KAPITI COAST DISTRICT COUNCIL

CODE COMPLIANCE CERTIFICATE

Street Address	40 Titoki Road, Waikanae
Valuation No.	1491017001
Legal Description	LOT 3 DP 386409 C/T 345892
Intended Use	Residential Dwelling
Intended Life	Indefinite, but not less than 50 years
Current Use	Vacant land
Proposal	New Dwelling
Estimated Value	$685,000

Drawing:
SITE PLAN
SCALE 1:300 @ A3

AMENDMENT FOR PERGOLA ADDITION
CROSS SECTION AA

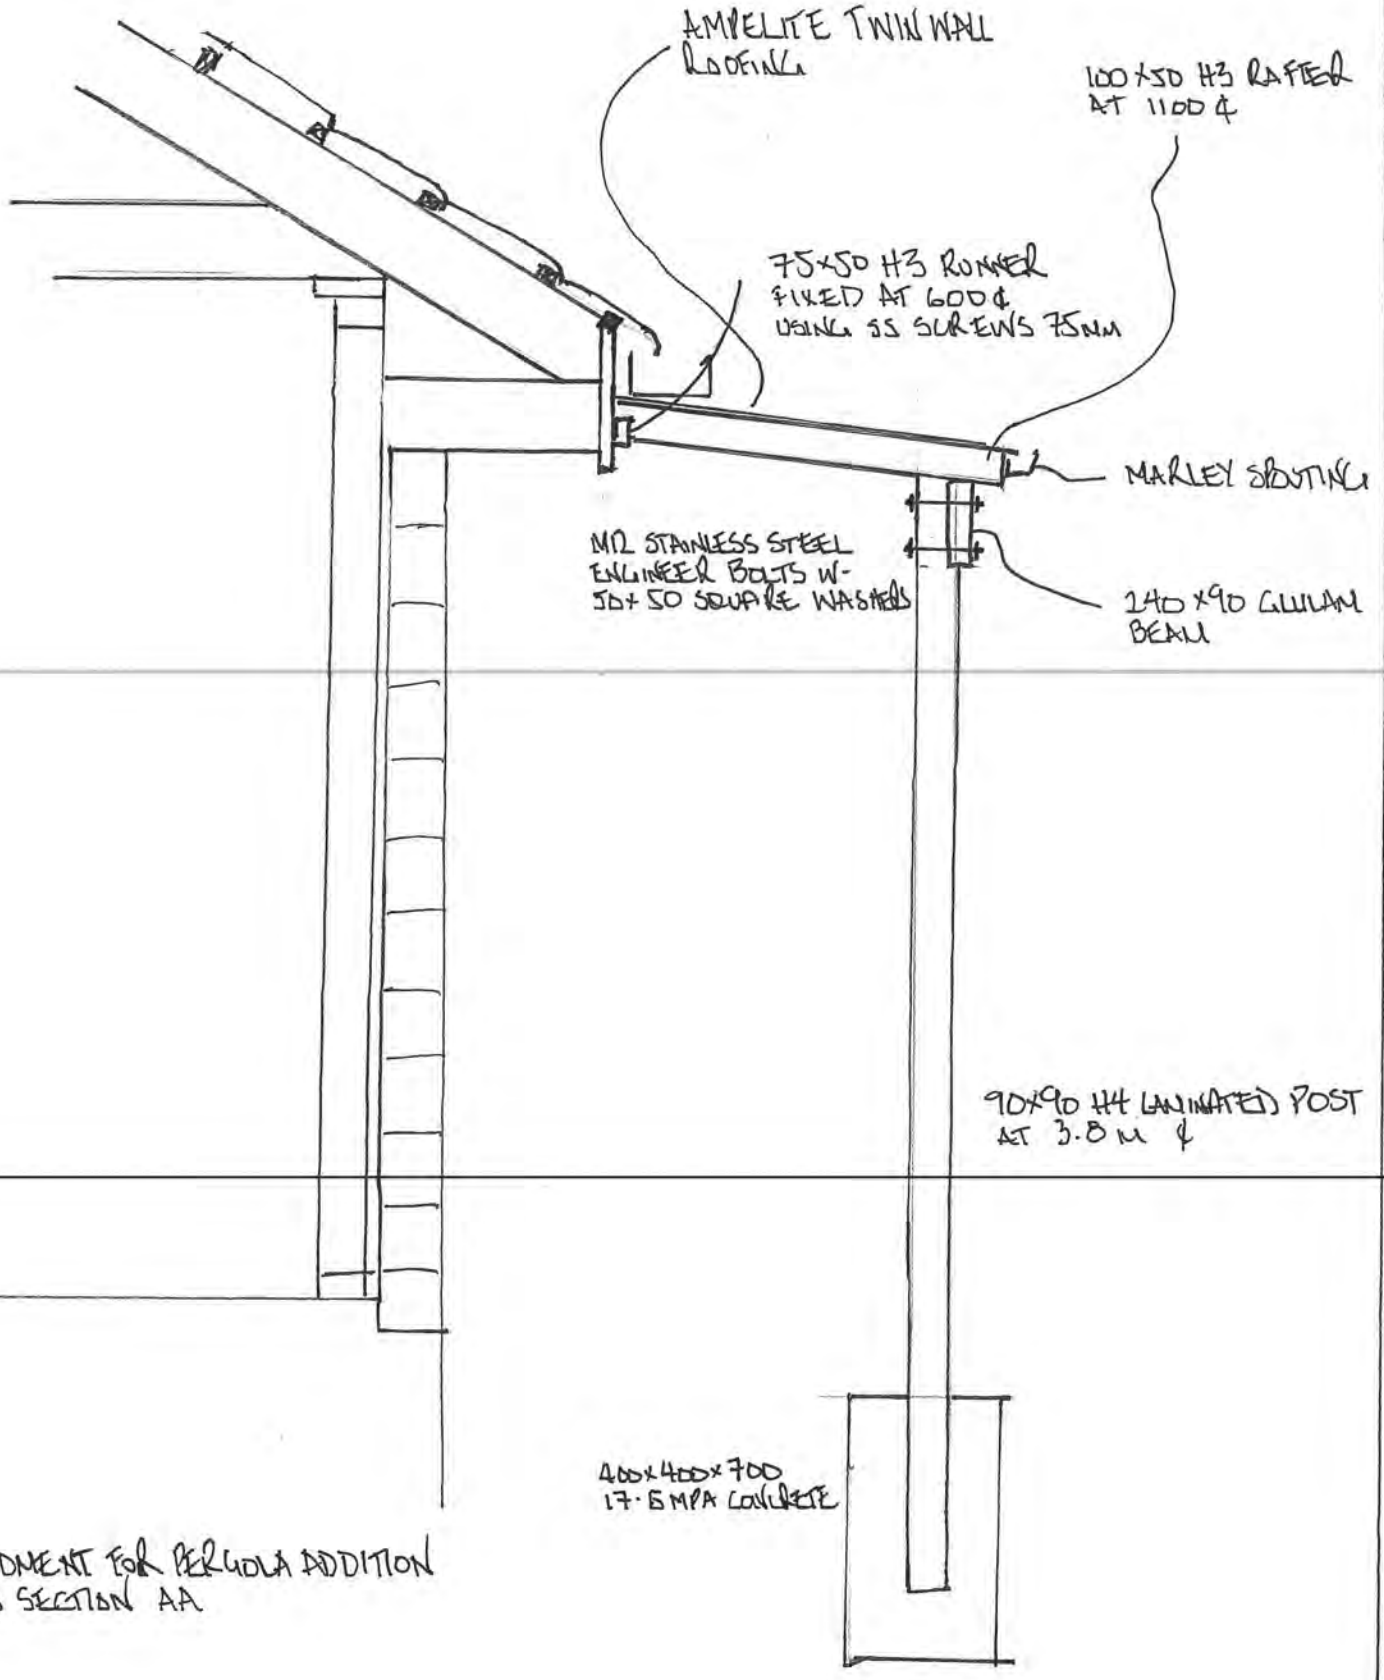
EXTERIOR - COMPLETE UNDER SILL JOINTS / INSTALL FLEXIBLE EXTERIOR TAP SLEEVES / COMPLETE FINAL COAT FOR SPOUTING & DOWN PIPES / COMPLETE AMENDMENTS FOR PERGOLA ADDITION AND CHANGE OF ROOF CLADDING TYPE / NOTED CONCRETE POSTS FOR PERGOLA & POST PERGOLA CONNECTIONS SHOULD BE GALVANISED TYPE WITH SEALED WASHERS BOTH SIDES
